TO: Mercedes-Benz Dealer Principals, General Managers, Sales Managers, Service Managers, Parts Managers	FROM: Gregory Gunther, Department Manager, Vehicle Compliance and Analysis, Engineering Services
RE: Service Campaign Launch Notification MY19 A-Class (177 platform) Correct Torque of Threaded Connection	DATE: May 10, 2019

Campaign No. 2019040022, May 2019

SUBJECT: **Model A-Class (177 platform) vehicles**
Model Year 2019

Correct the torque of the threaded connection on the left and right rear axle torsion bar

Figure 1

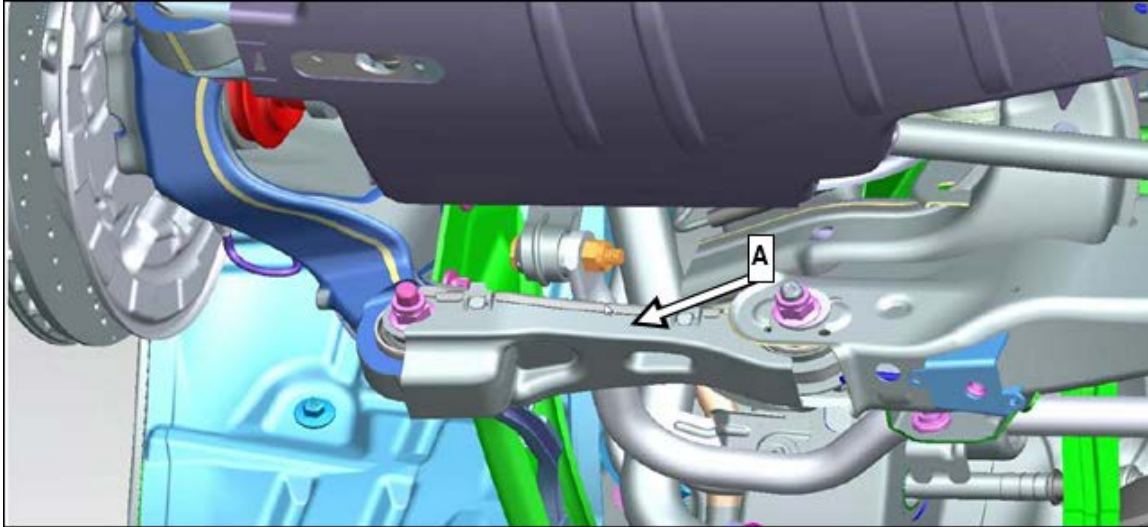
1. Lift vehicle with vehicle lift.
 i For basic data, see **AR00.60-P-1006A**.
2. Remove trim (**A, figure 1**) of tie rod on rear axle at left and right.
 i Unclip and remove trim on tie rod.

Figure 2

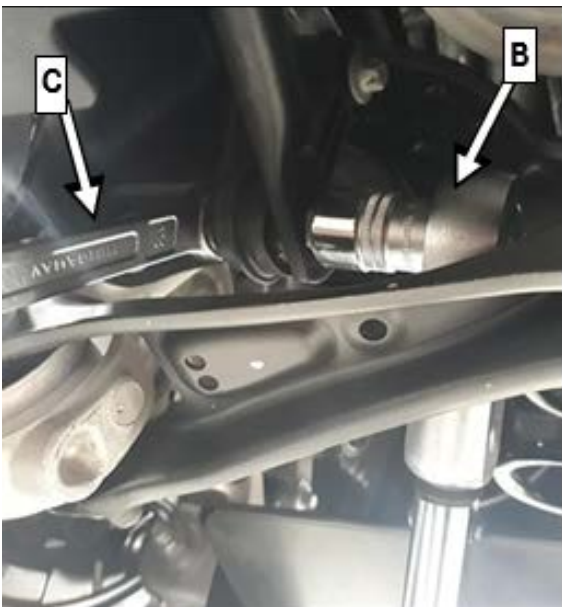
3. Correct torque of threaded connection of torsion bar linkage at left and right (**figure 2**).
 i The threaded connection must ***not*** be unfastened.
 i To correct the torque, a torque wrench (**B**) and a counter wrench (**C**) must be used (**figure 2**).
 i The torque of the threaded connection of the torsion bar linkage on the rear axle is **Nm** **80 +/-8**.
